UNITED STATES PATENT AND TRADEMARK OFFICE

APPLICATION NO.	FILING DATE	FIRST NAMED INVENTOR	ATTORNEY DOCKET NO.	CONFIRMATION NO.
10/595,355	04/12/2006	Takco Arai	09792909-6657	8112
26263 7590 08/02/2007 SONNENSCHN NATH & ROSENTHAL LLP P.O. BOX 061080 WACKER DRIVE STATION, SEARS TOWER CHICAGO, IL 60606-1080			EXAMINER KANG, EDMUND C	
			ART UNIT 2885	PAPER NUMBER
			MAIL DATE 08/02/2007	DELIVERY MODE PAPER

Office Action Summary	Application No. 10/595,355	Applicant(s) ARAI ET AL.	
	Examiner Edmund C. Kang	Art Unit 2885

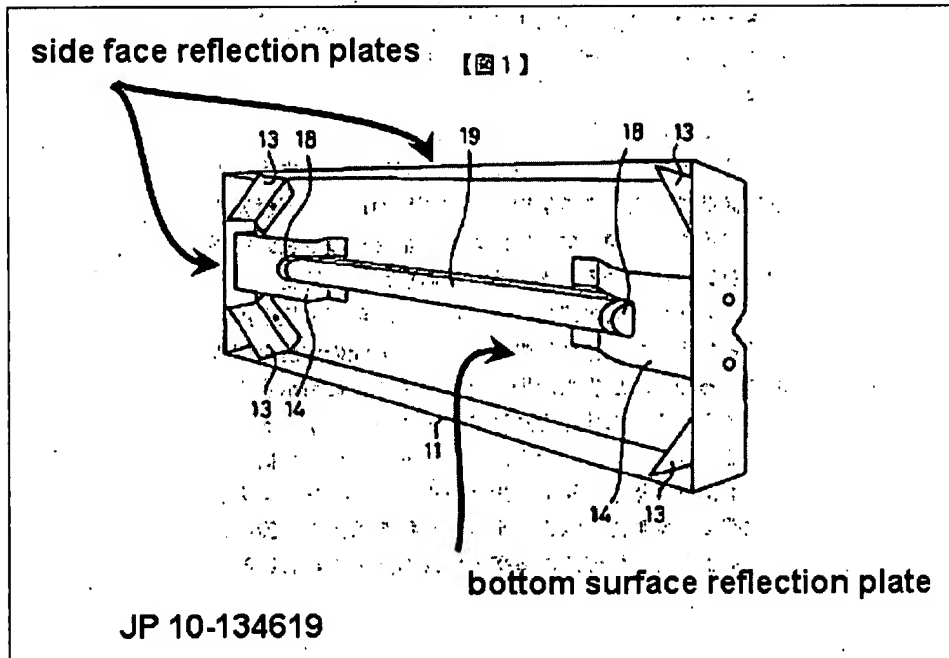
wherein the reflection plate is composed of a bottom surface reflection plate (see annotated Fig. 1 below) for reflecting, from the bottom surface direction, rays of light emitted from the light source unit, side face reflection plates (annotated Fig. 1) for reflecting rays of light emitted from respective forward and backward, and left and right side surface directions, and corner reflection plates (Figs. 1-3, **13**) for covering respective corner portions where the bottom surface reflection plate and the side surface reflection plates are connected.

wherein a reflection surface (Abstract, line 11-12, "...whose reflection surfaces include mirror surface luster...") of the corner reflection plate takes polygonal shape (Figs. 1 and 3 – corner reflection plates 13 are polygonal, specifically rectangular).

wherein a reflection surface (Abstract, line 11-12, "...whose reflection surfaces include mirror surface luster...") of the corner reflection plates take flat plate shape (Figs. 1 and 3 – corner reflection plates are flat plates, specifically rectangular planes).
